Informal document **GRPE-85-39**
85th GRPE meeting, January 2022
Agenda Item 8(b)

**Proposal for amendments to GRPE/2022/7
(draft DUR GTR) in a consolidated version**

Proposal for amendments to draft new GTR on Durability (GRPE/2022/7) are marked in track changes. This document contains the consolidated version.

**Proposal for a new UN GTR on the measurement procedure
for two- or three-wheeled vehicles equipped with a
combustion engine with regard to durability of pollution-
control devices**

Figure 3
 Theoretical example of the plotted Type I total hydrocarbon (THC) emission test results, the plotted Type I THC Euro 4 test limit (170 mg/km) and the best-fit straight trend line of a Euro 4 motorcycle ($v_{max} > 130$ km/h), all versus accumulated distance.

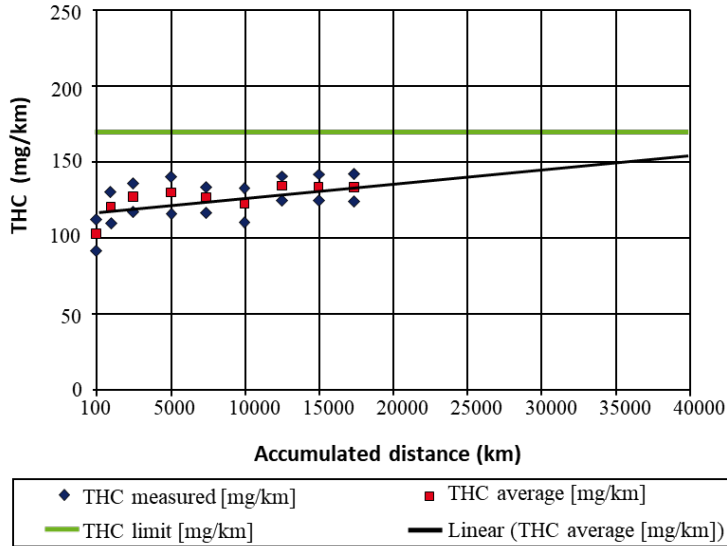
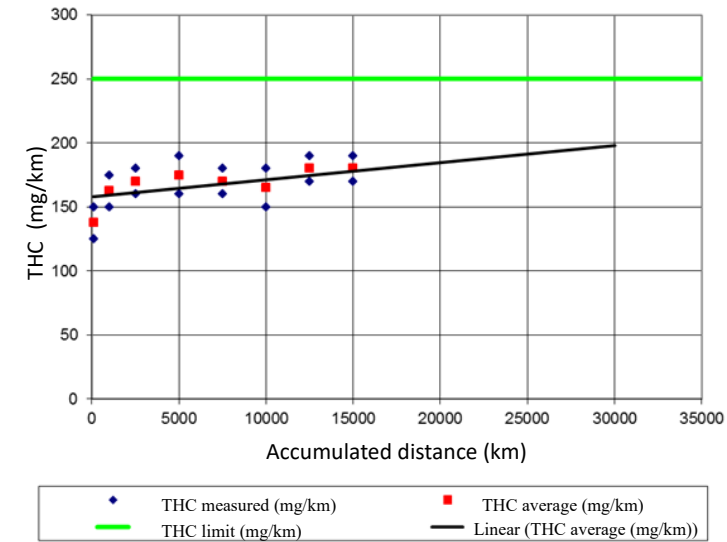
Commented [EPPR3]: Fig. 3 changed
